EXHIBIT B

W. 3RD ST & PACIFIC AVENUE

SITE PLAN REVIEW

09.10.2019

TYPICAL BALCONY SECTION

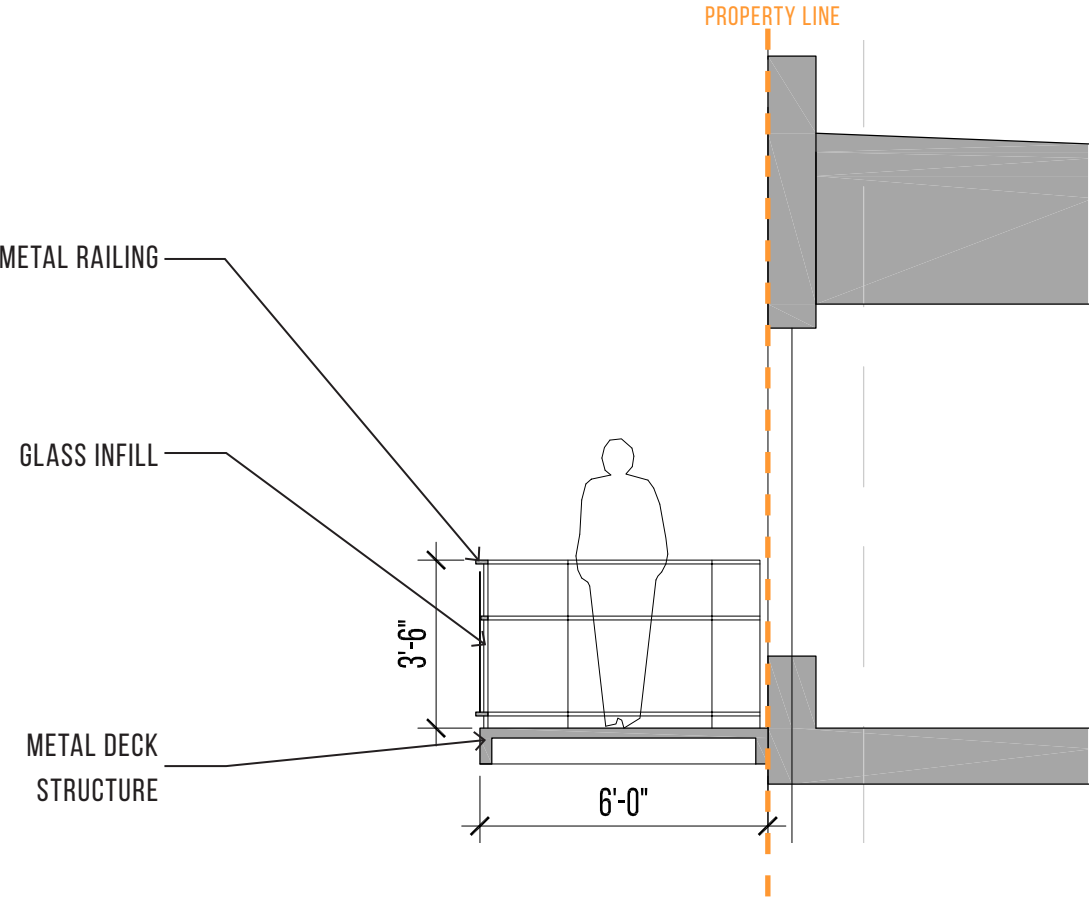
c. Bike parking. The parking table on page 11 now includes calculations for the required residential and commercial bicycle parking for each building.
5. Elevations/Sections
- a. A balcony section is shown on page 17.

PHASING DIAGRAM - PHASE 1 (NORTH)

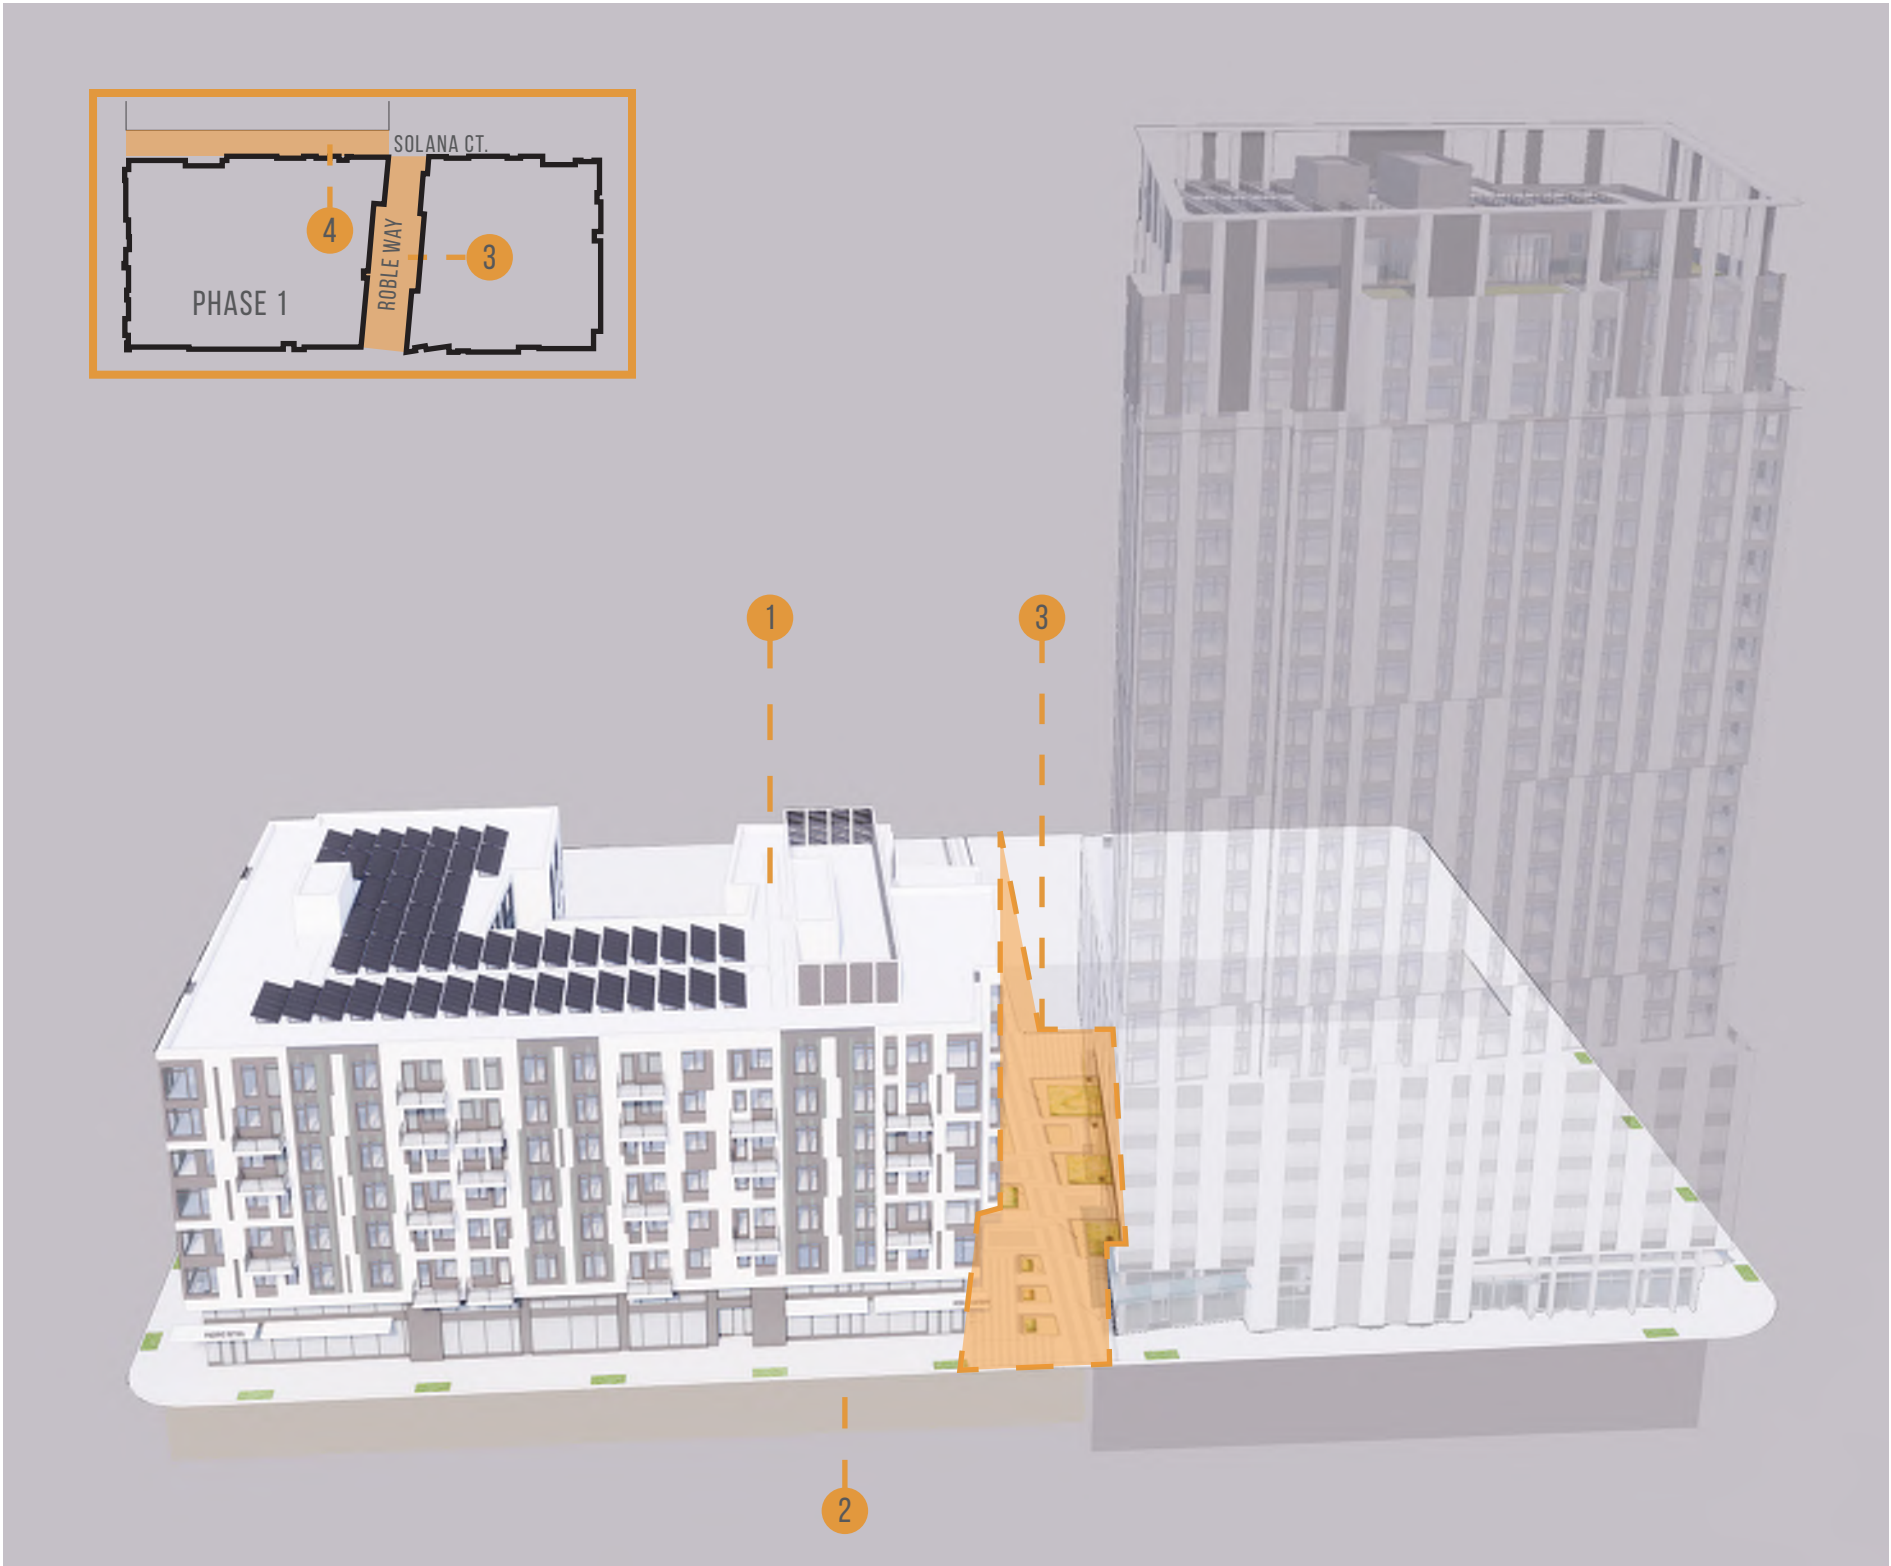
1. Project Summary
- a. Phasing. A phasing plan for the two buildings is now included in this package.

OVERALL SITE PLAN

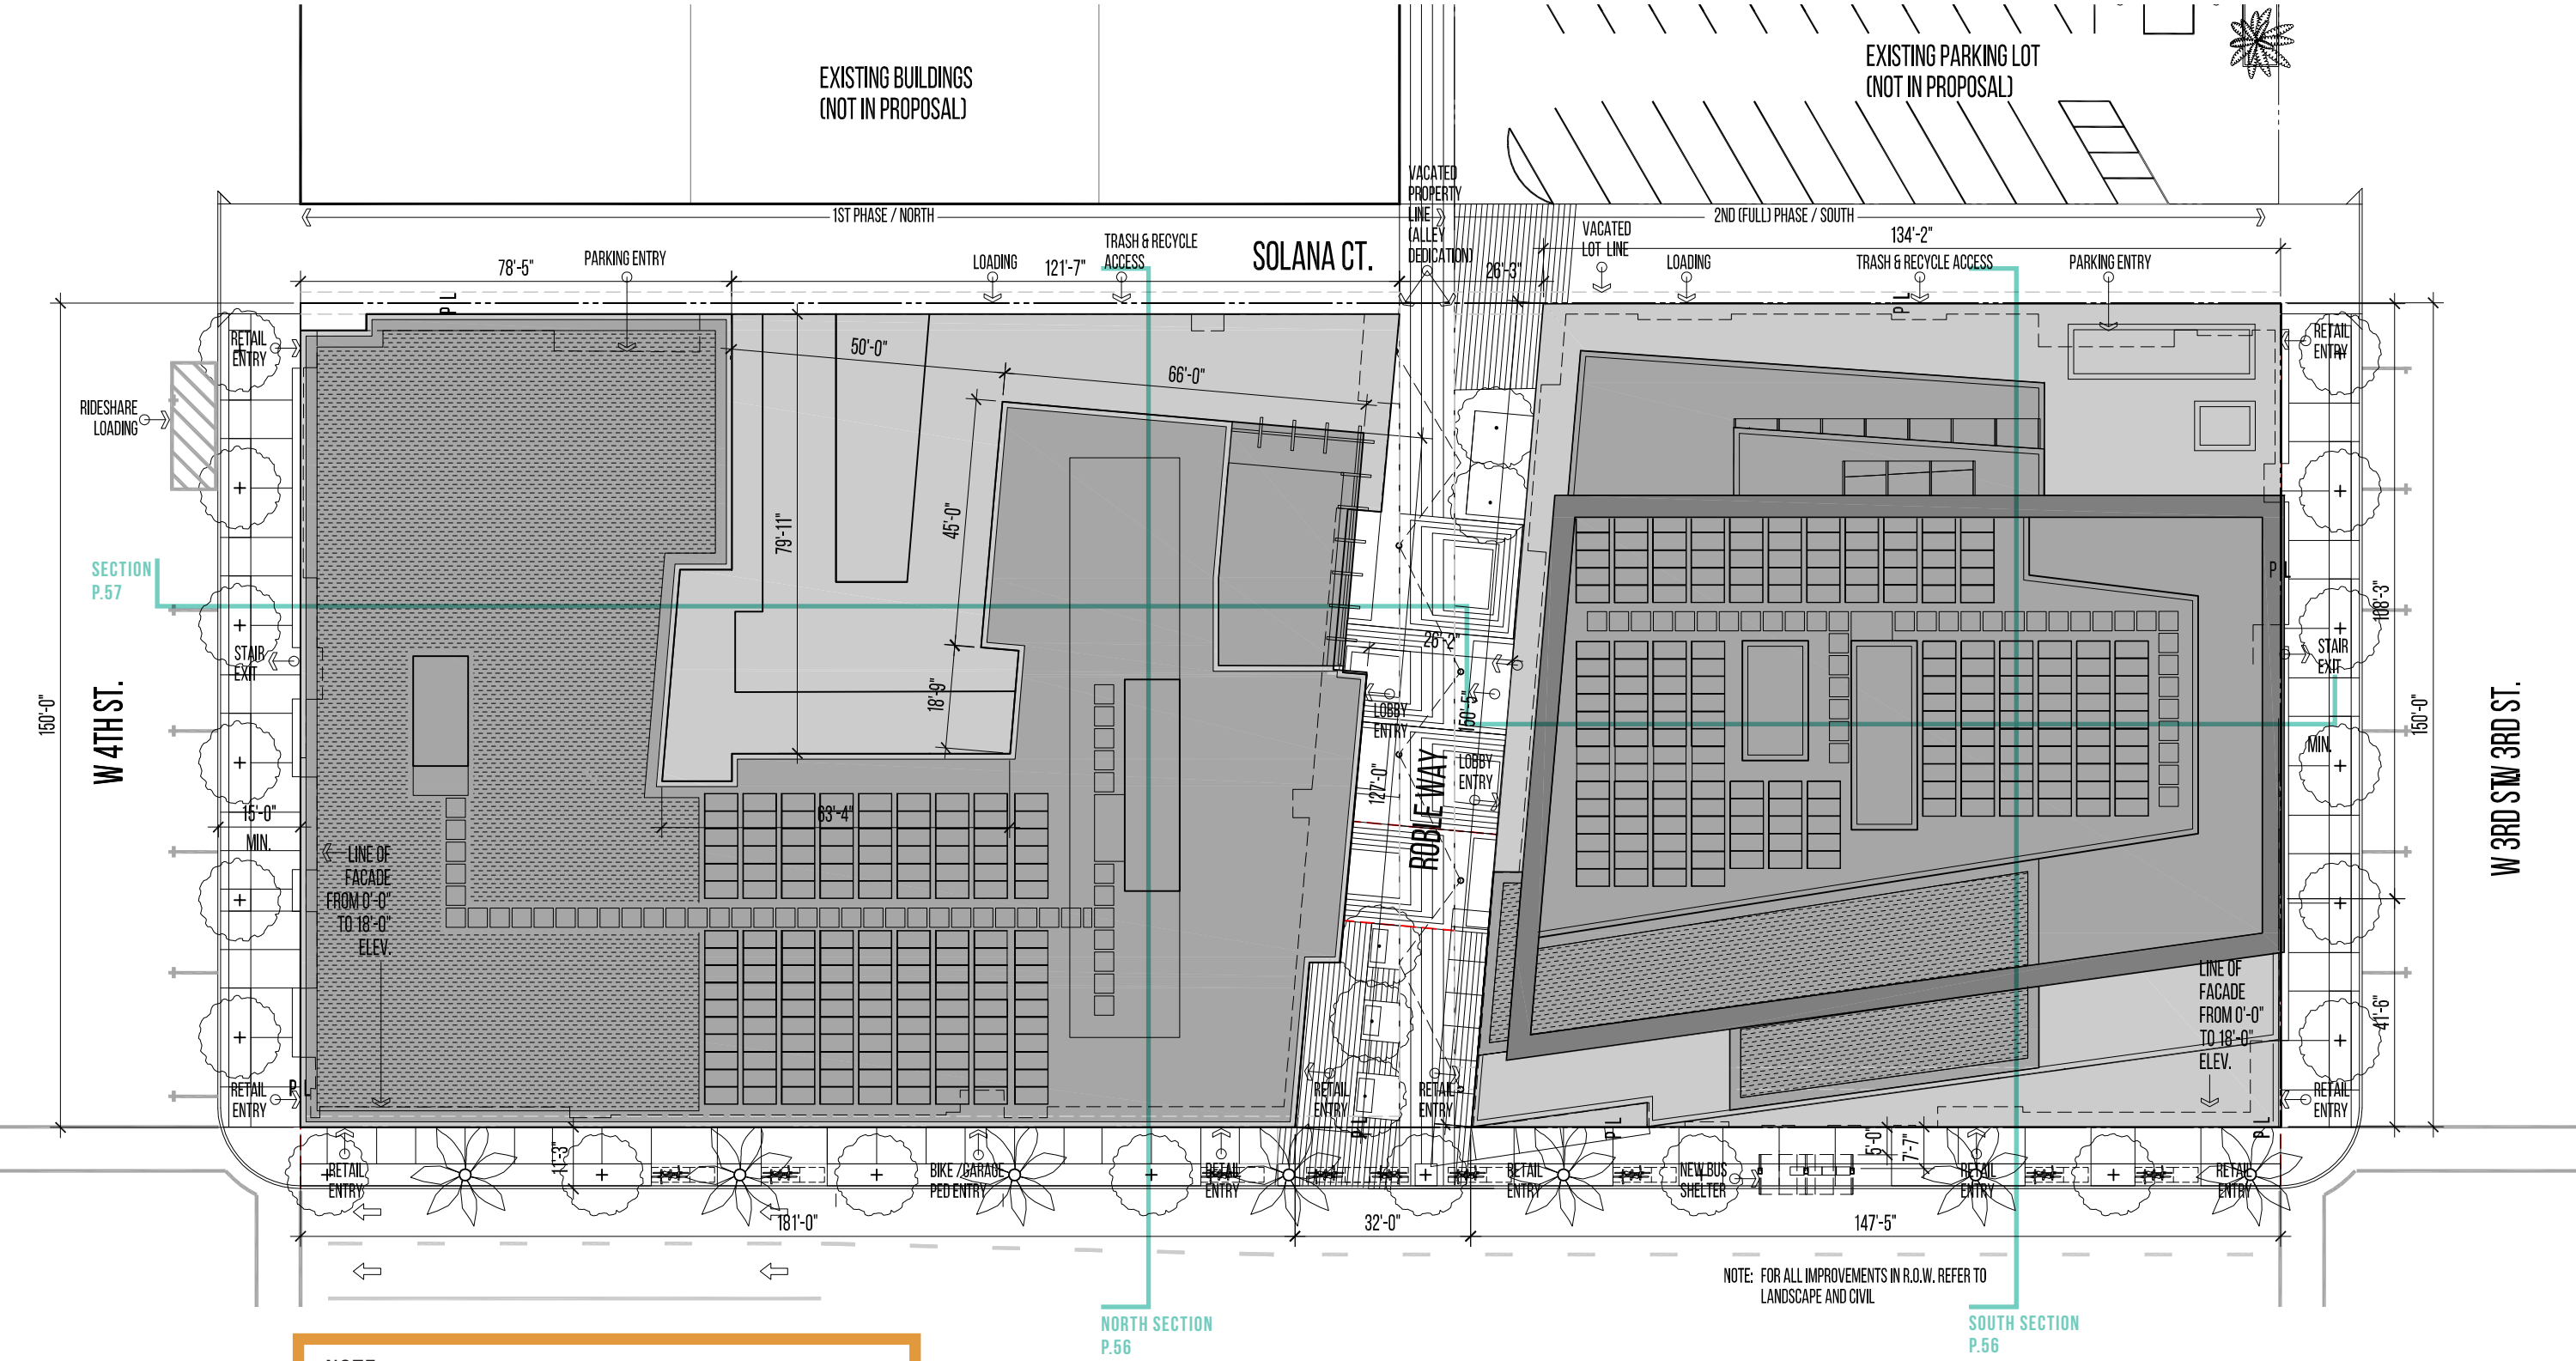
A Ride Share staging area is now shown on the site plan.
The architecture of the midrise building’s northwest corner at 4th and Pacific serves two primary functions in the design. At the ground floor, the building walls step back at the corner to activate that pedestrian zone and provide entry for retail. At a building scale, the facade above hosts prime corner apartments internally, and externally uses cladding material patterns to “turn the corner” in leading the composition of the development to the central Roble way Paseo that is the anchor for the development and main entry for both apartment buildings. The architecture of that corner should be reflective of the building uses there. It is also necessarily subservient in composition to the central entry of the project development at mid-block.

Building sections tags on the site plan have been updated to accurately reflect the corresponding views.

ENLARGED UNIT PLANS (PHASE 1) - LESS THAN 600 SF

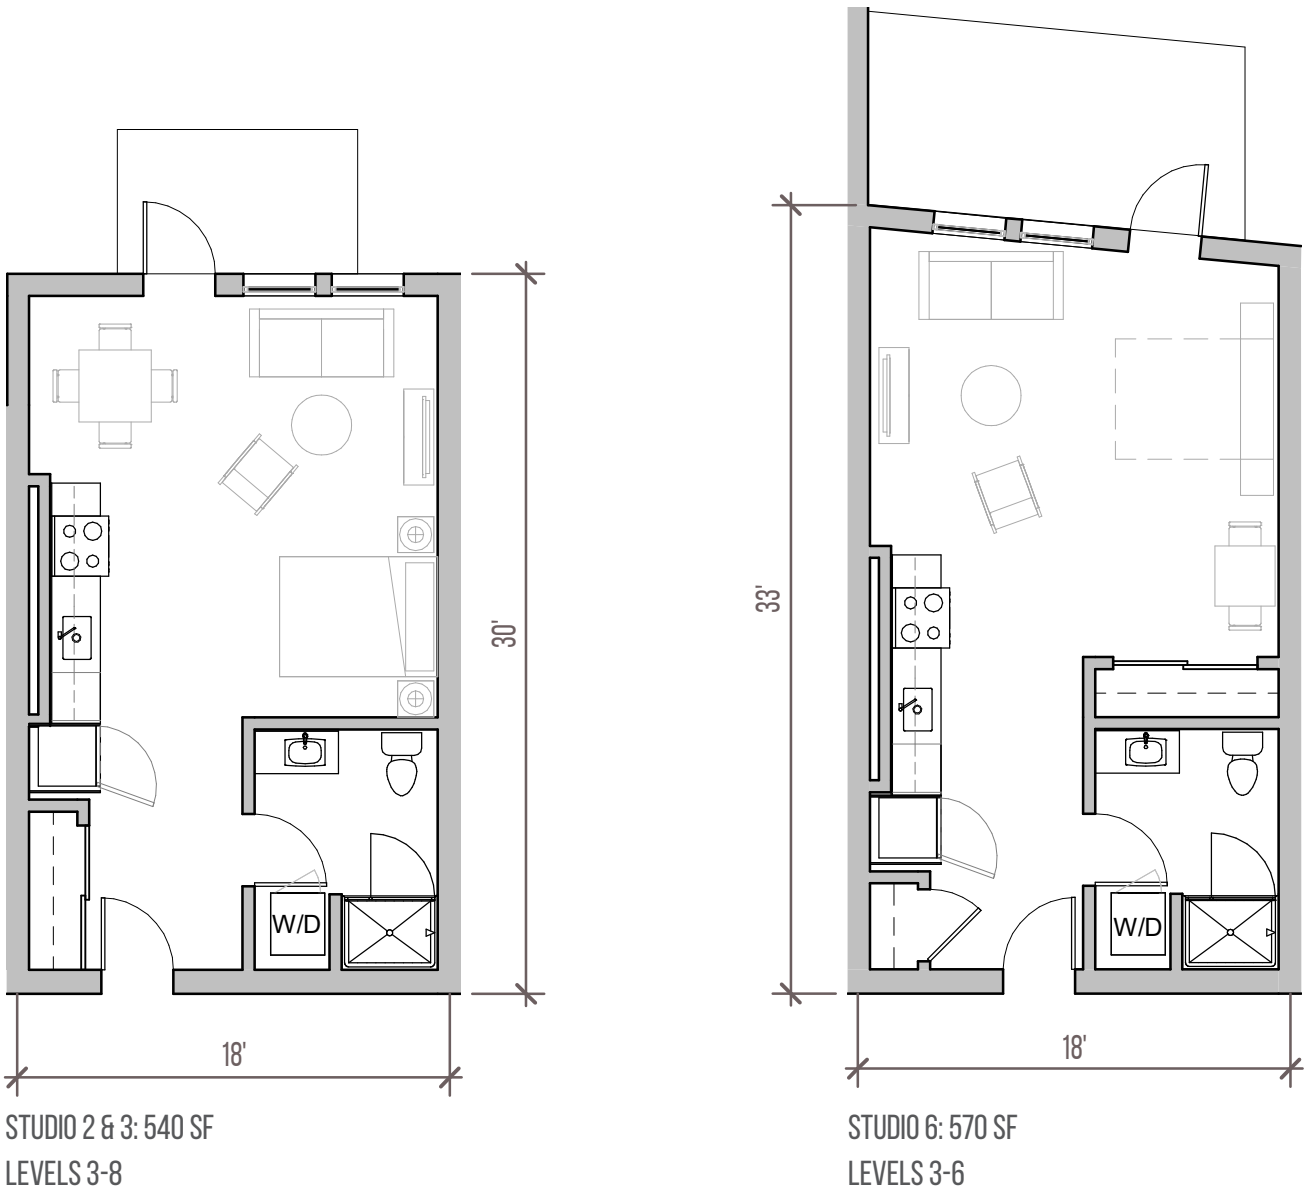
The midrise building proposes 16 of the 142 total apartments to be smaller than 600 square feet in area, for a 11.3% ratio. In the south high rise, all the apartments are larger than 600 square feet in area. See the enlarged unit plan sheet for details of those units smaller than 600 square feet.

The midrise building proposes 16 of the 142 total apartments to be smaller than 600 square feet in area, for a 11.3% ratio. In the south high rise, all the apartments are larger than 600 square feet in area. The reduced-size units further meets the requirements of the Downtown Plan by providing a mix of dwelling unit types and sizes. The units are desirable, high-quality dwelling units that will promote a balanced community and will have a variety of features and amenities, including but are not limited to the following:
